**ADDENDUM #1**  
**To the Bid Documents for the**  
**Family Aquatic Center HVAC and Pool Deck Project 2023**  
**Oak Brook Park District**

**SECTION 00 91 01  
ADDENDUM NUMBER 1**

**PROJECT:** FAMILY REC CENTER POOL DECK & HVAC RENOVATIONS  
1450 OAK FOREST GATE ROAD  
OAK BROOK, ILLINOIS

**PROJECT NO:** 22-310-1444

ISSUED	11/20/22	OUT TO BID / IDPH REVIEW
JOB NO.	22-310-1444	
DRAWN	CDJ	
CHECKED	CDH	
APPROVED	AN	
SHEET TITLE		
ALTERNATE #1 OR #2 ARCHITECTURAL FLOOR PLAN		
SHEET NUMBER		
<b>A310</b>

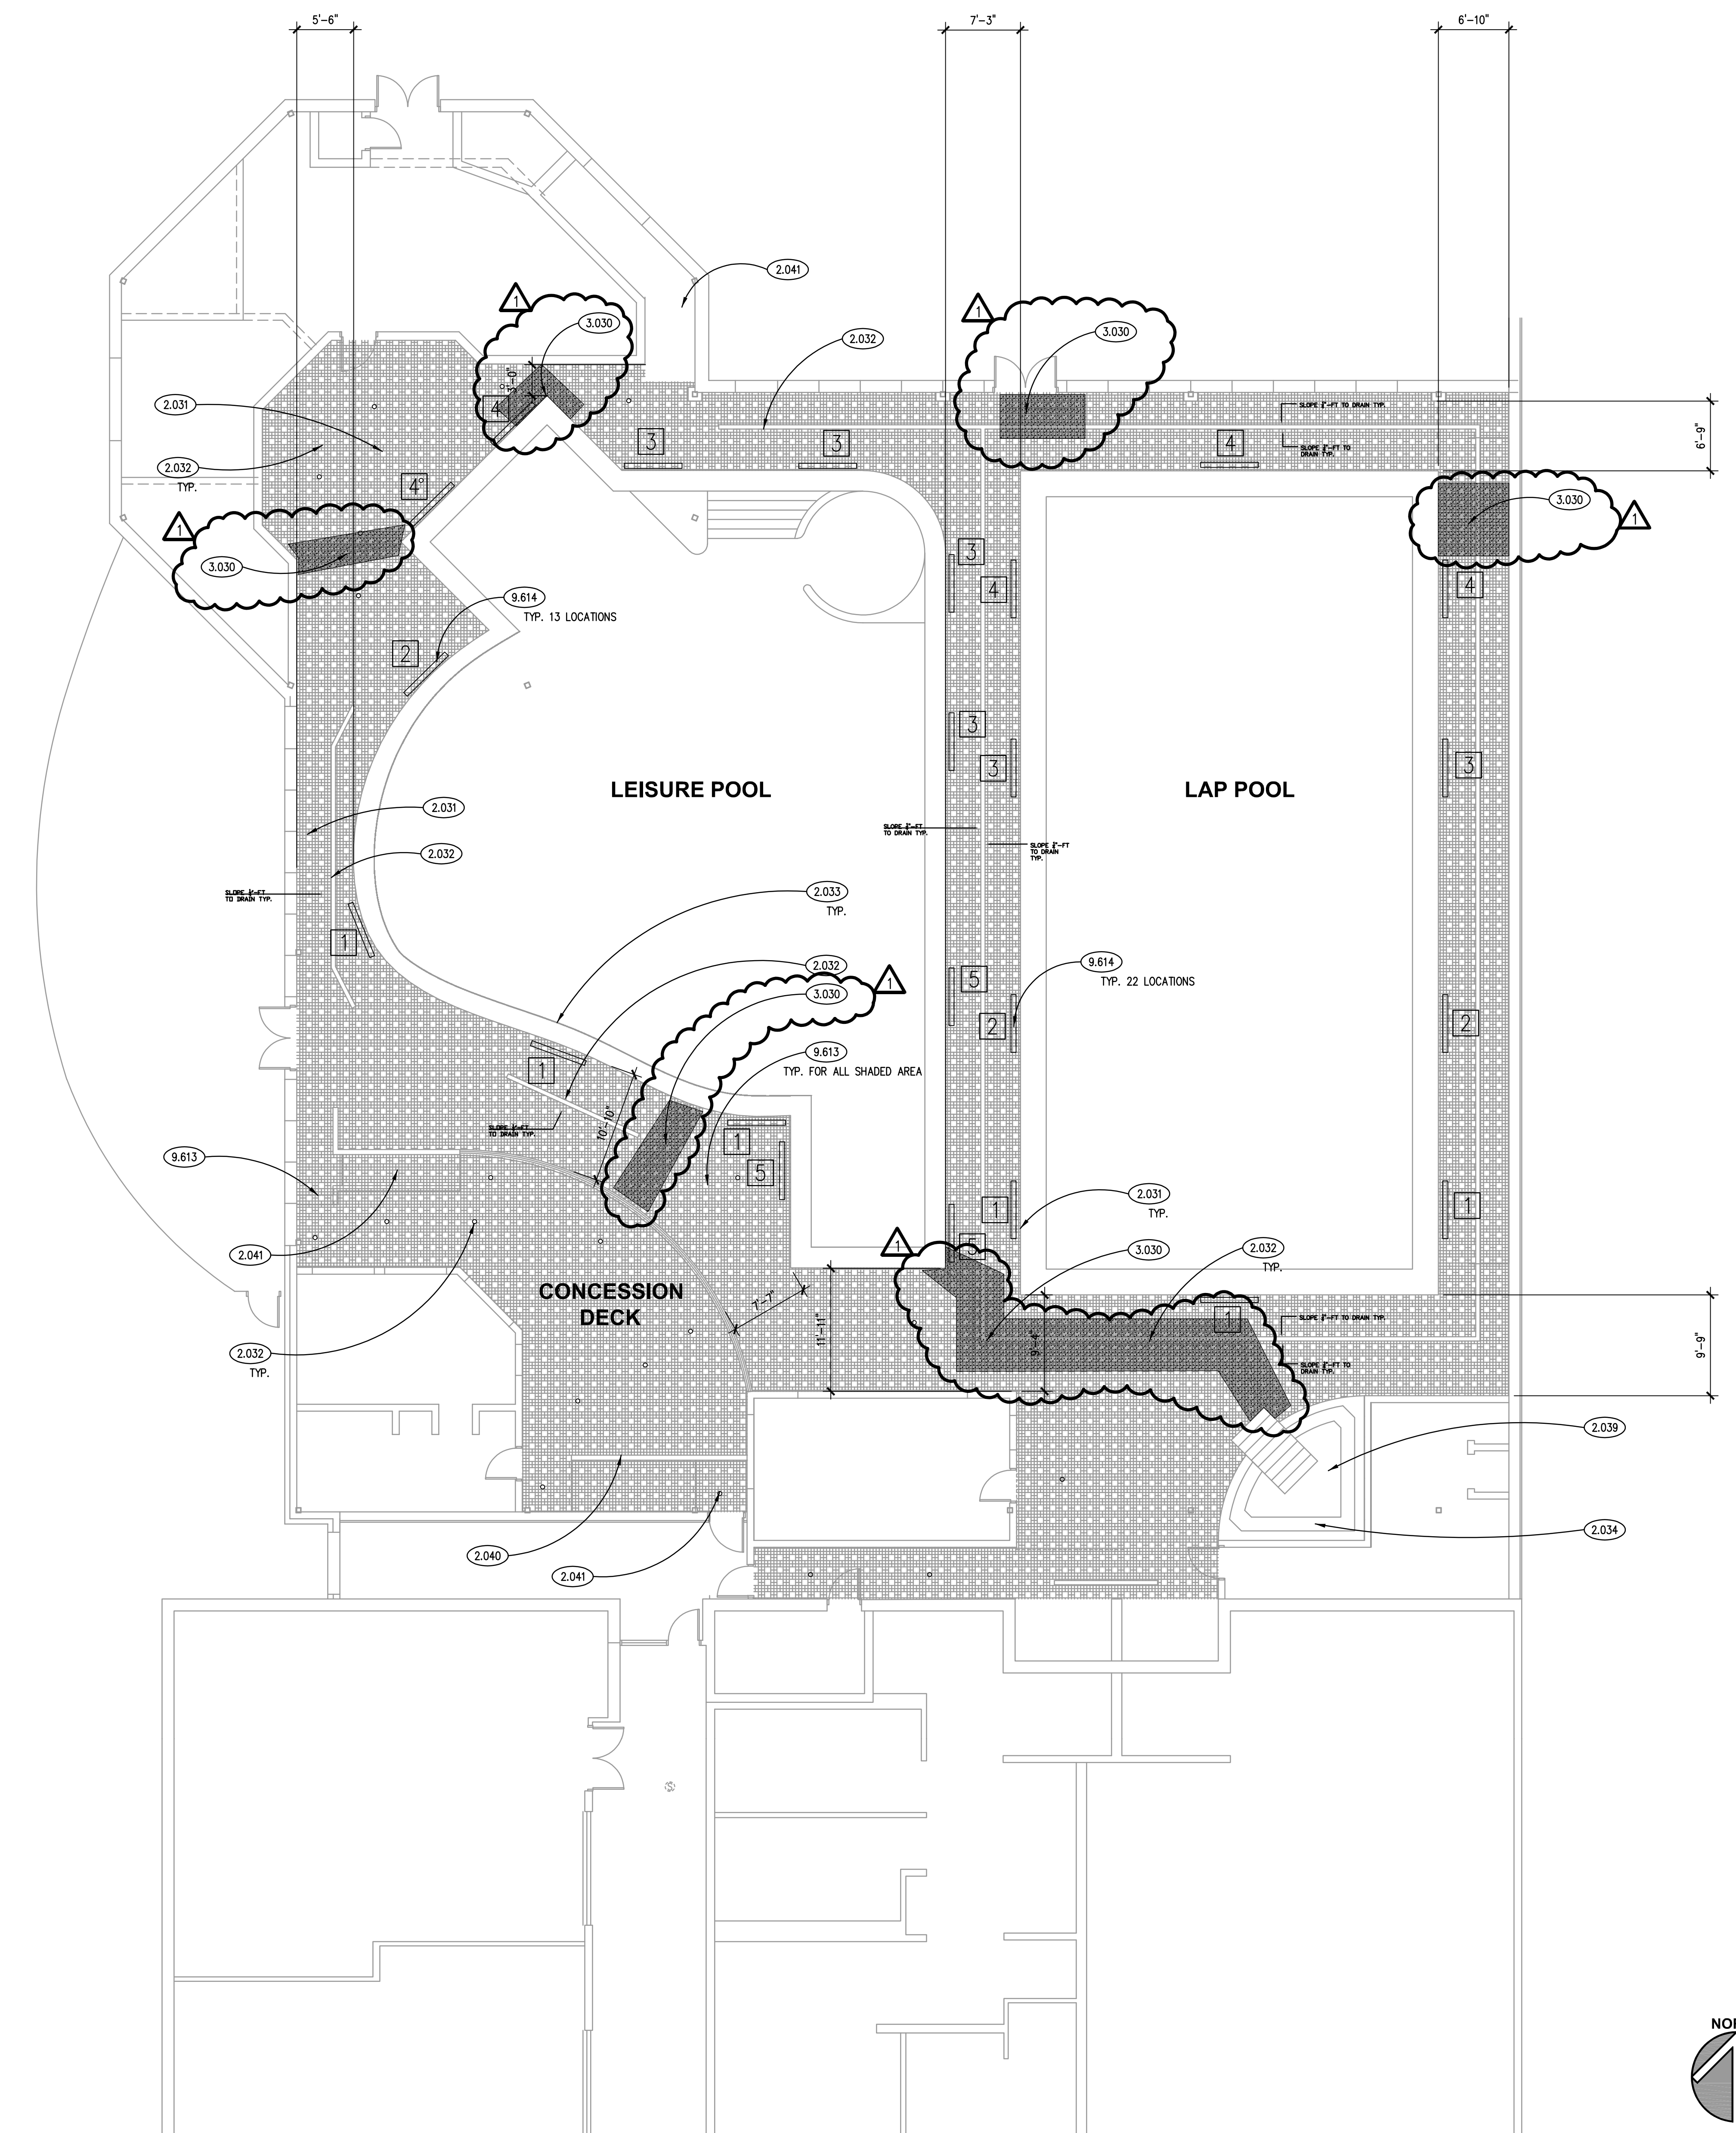
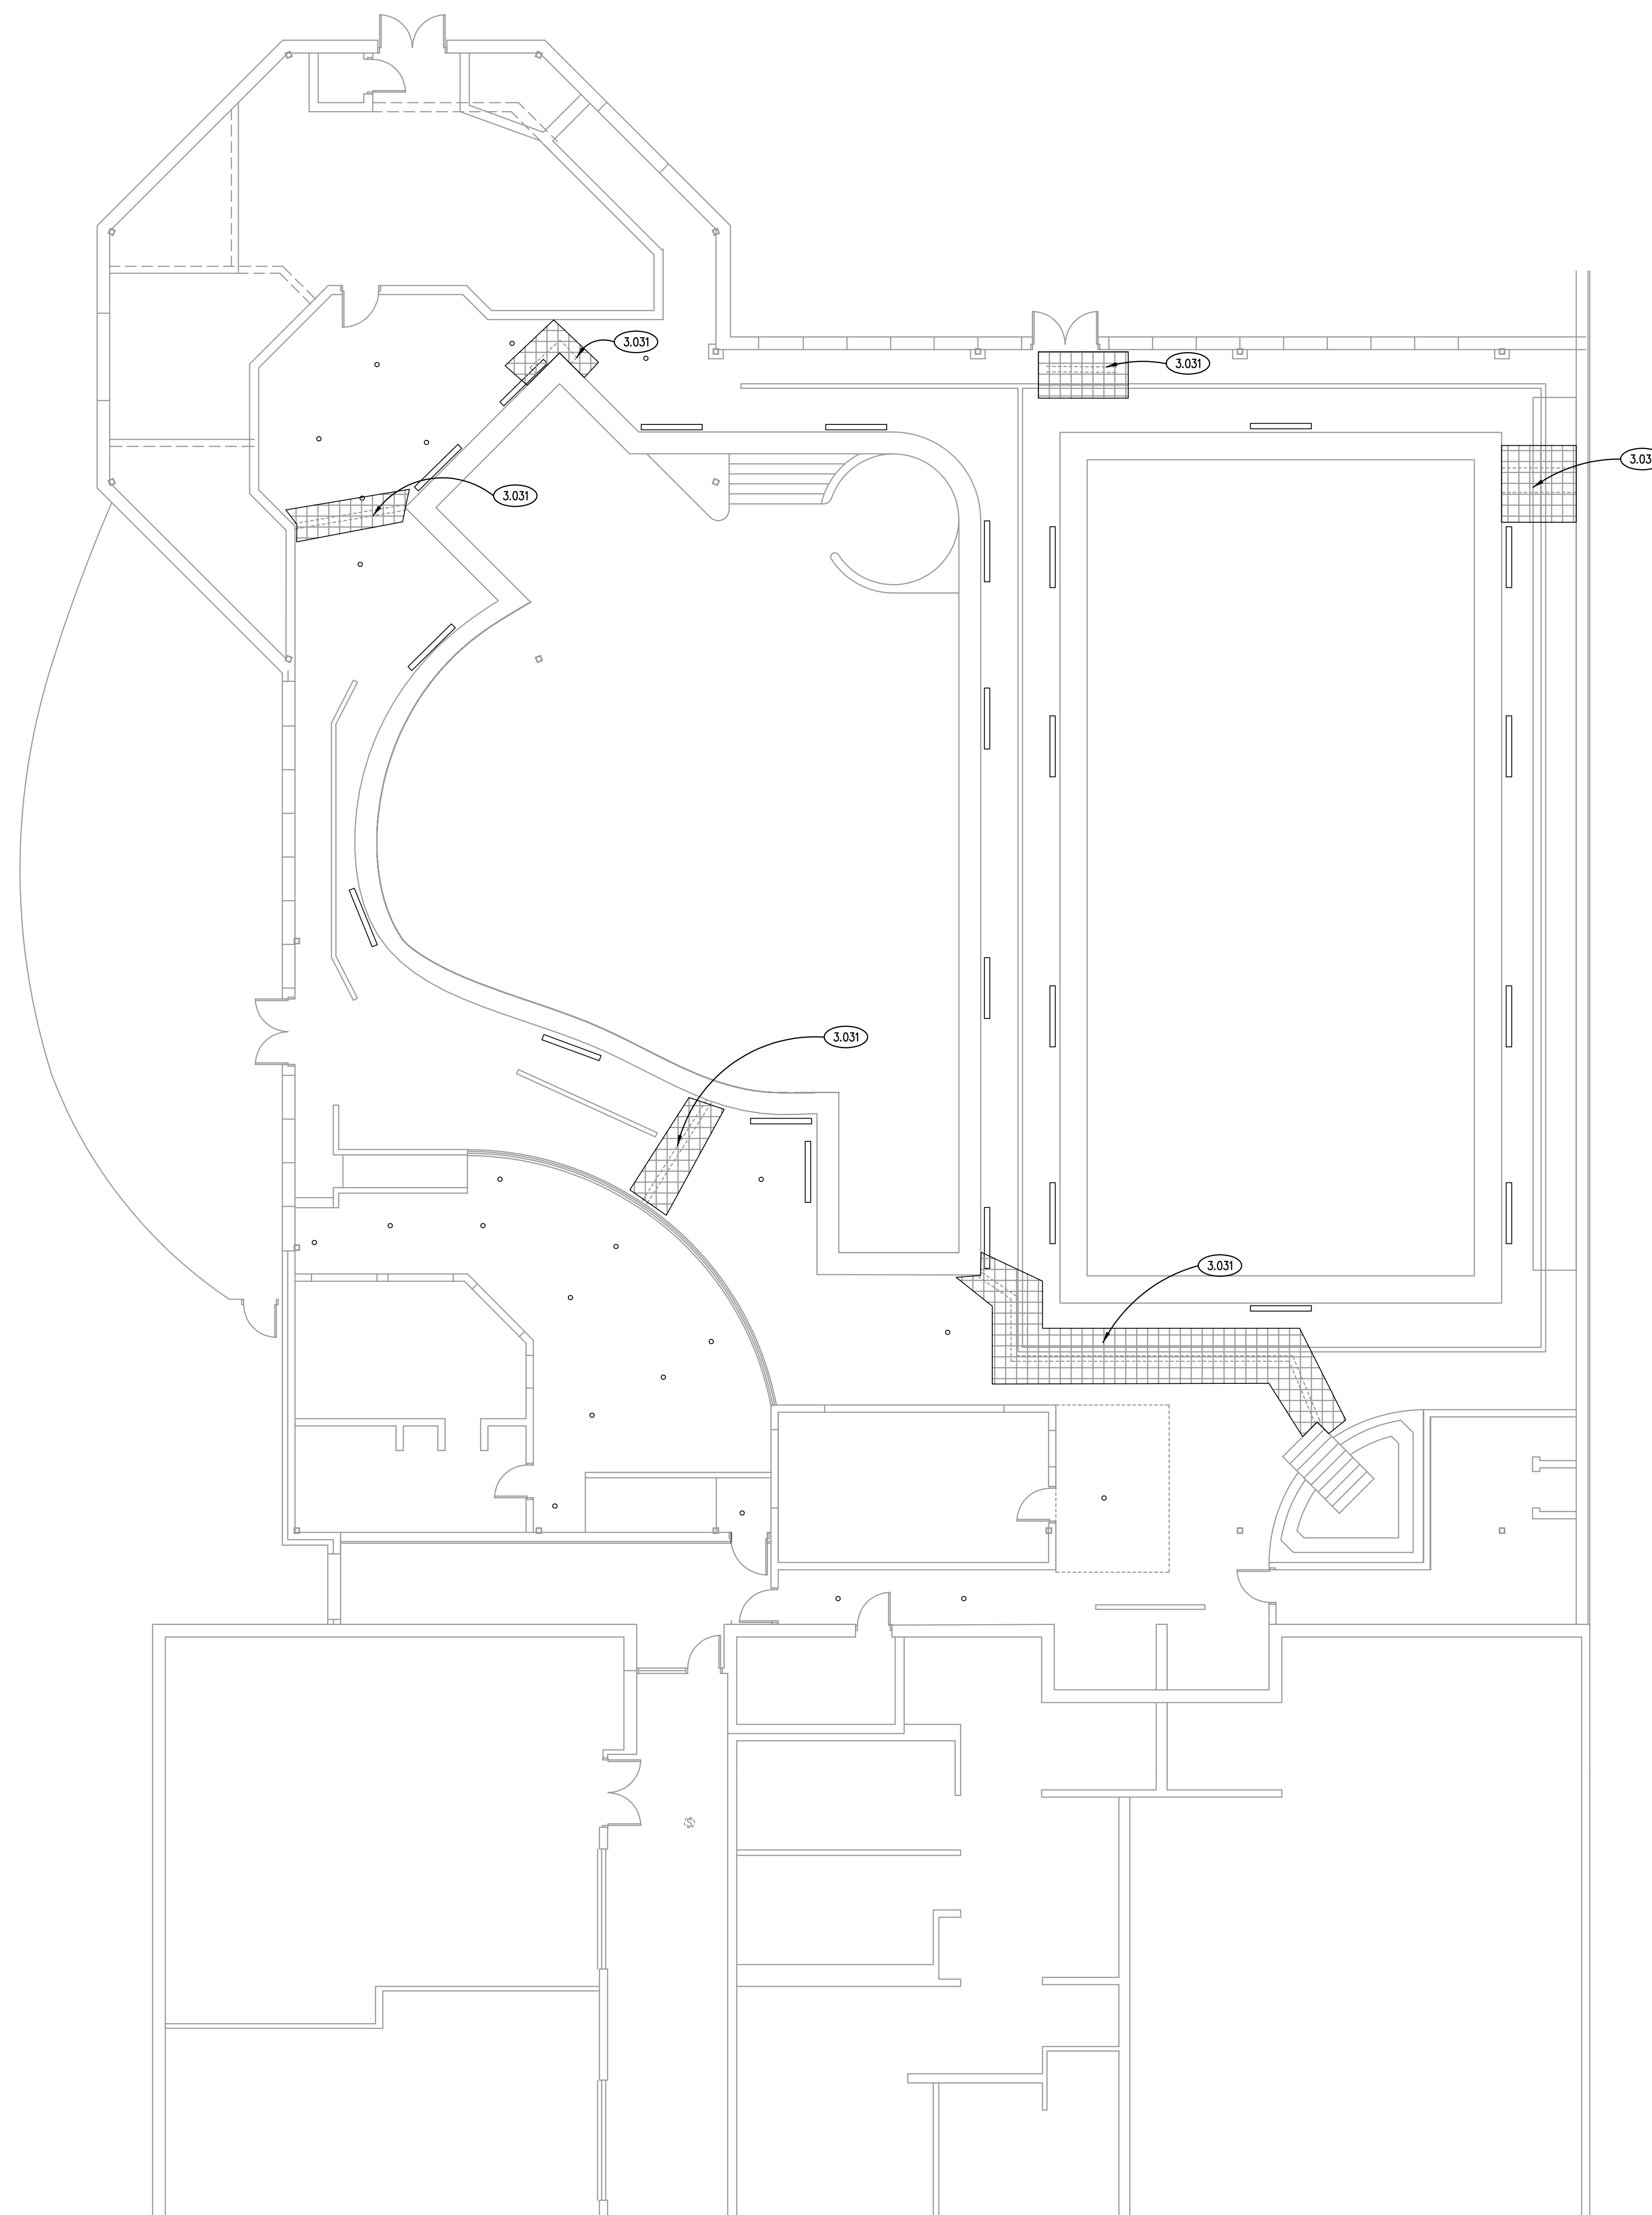
### **5.01 DRAWING A310 - ALTERNATE #1 OR #2 ARCHITECTURAL FLOOR PLAN**

A. Replace A310 - Architectural Floor plan sheet with attached A310 - Architectural Floor plan sheet.

3.030 CAST-IN-PLACE CONCRETE: IN AREAS WHERE CONCRETE INVESTIGATION WARRANT REPLACEMENT, REPLACE FULL CONCRETE SQUARE FULL DEPTH OF POOL DECK (BETWEEN 5' - 0" - 6"). EXISTING DECK DRAINS AND DRAIN BODIES ARE TO REMAIN. PROTECT DURING CONSTRUCTION. MATCH EXISTING ELEVATION AND SLOPE OF REMOVED CONCRETE. PROVIDE REINFORCED CONCRETE BOWELED INTO EXISTING SLAB. REFER TO BONDING PLAN FOR BONDING GRID INFORMATION.

ISSUED	11/20/22	OUT TO BID / RFP REVIEW
JOB NO.	22-310-1444	
DRAWN	CDJ	
CHECKED	CDH	
APPROVED	AN	
SHEET TITLE		
ALTERNATE #1 OR #2 BONDING FLOOR PLAN		
SHEET NUMBER		
<b>A315</b>

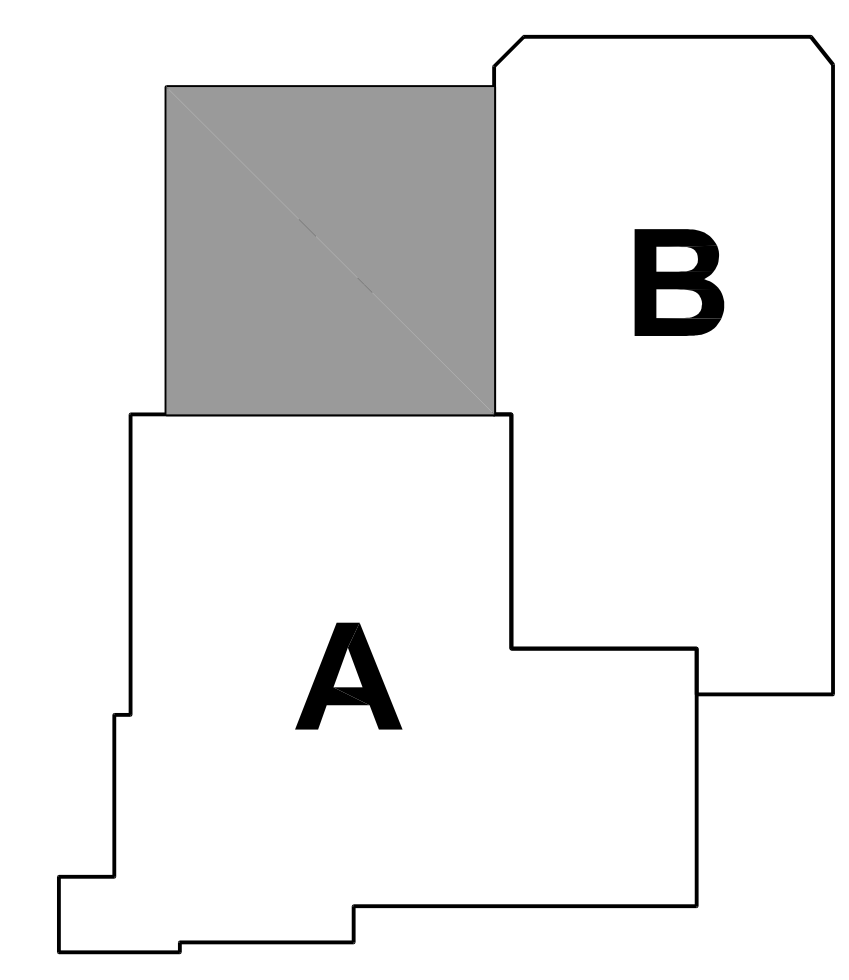
### **5.02 DRAWING A315 - ALTERNATE #1 OR #2 BONDING FLOOR PLAN**

A. Add sheet A315 - Alternate #1 or #2 Bonding floor plan to set.

3.031 CAST-IN-PLACE CONCRETE: EQUIPOTENTIAL BONDING GRID FORMED BY REINFORCING STEEL. MAXIMUM 12" X 12" GRID. STANDARD WIRE TIES AT INTERSECTIONS. MUST TIE INTO EXISTING BONDING GRID AND REMAIN NEUTRAL CHARGE. VERIFY EXISTING GRID CHARGE PRIOR TO TIE IN.
